SERVICE INFORMATION BULLETIN

NUMBER: 03-97-26

SUBJECT: Service Manual Correction / Clutch Master
 Cylinder Reservoir Seal

1. MASTER CYLINDER OIL SEAL

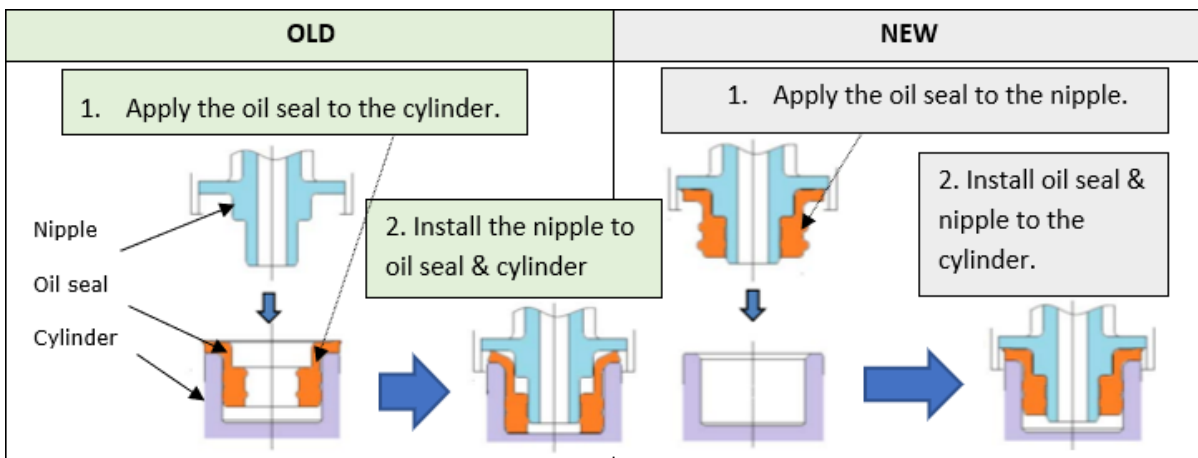
The current version of the Service Manual instructs installing the oil seal to the cylinder.

This will be revised to specify installation of the oil seal to the nipple.

EXAMPLE:

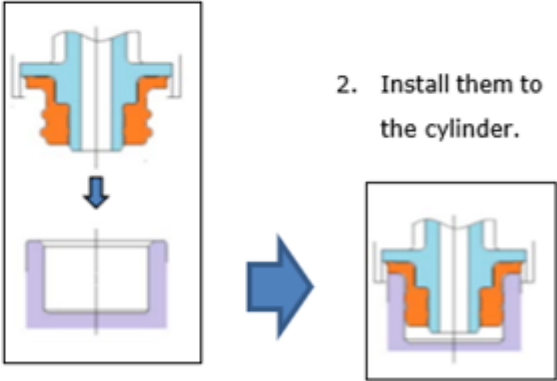
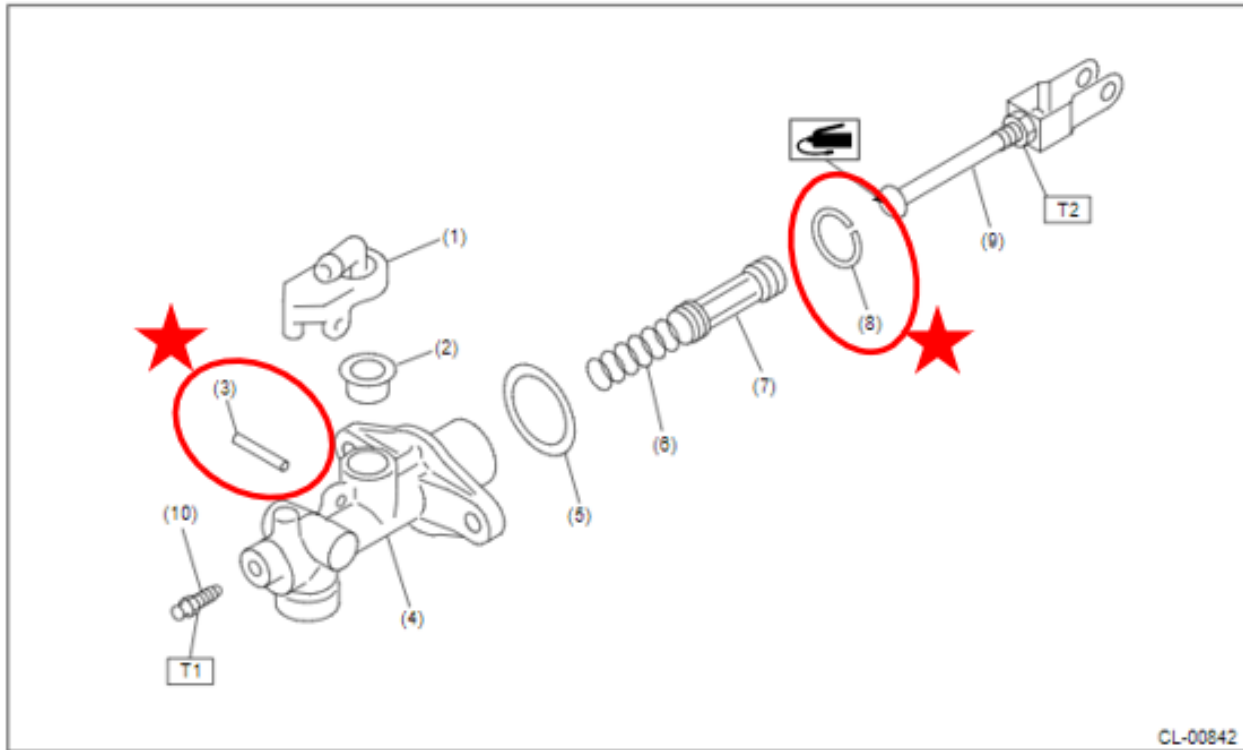
2018MY Forester is shown for example purposes.

OLD	NEW
<p>1. Apply a coat of grease to the contact surfaces of the push rod and piston before installation. Grease: SILICONE GREASE G-40M or equivalent</p> <p>2. Assemble in the reverse order of disassembly. Tightening torque: 10 N·m (1.0 kgf·m, 7.4 ft-lb)</p>	<p>1. Apply a coat of grease to the contact surfaces of the push rod and piston before installation. Grease: SILICONE GREASE G-40M or equivalent</p> <p>2. Install the piston stop ring.</p> <p>3. Install the seat.</p> <p>4. Install the oil seal to the nipple.</p> <p>1. Apply the oil seal to the nipple.</p>  <p>2. Install them to the cylinder.</p> <p>5. Install the straight pin and nipple with the seal.</p> <p>Tightening torque: 10 N·m (1.0 kgf·m, 7.4 ft-lb)</p>
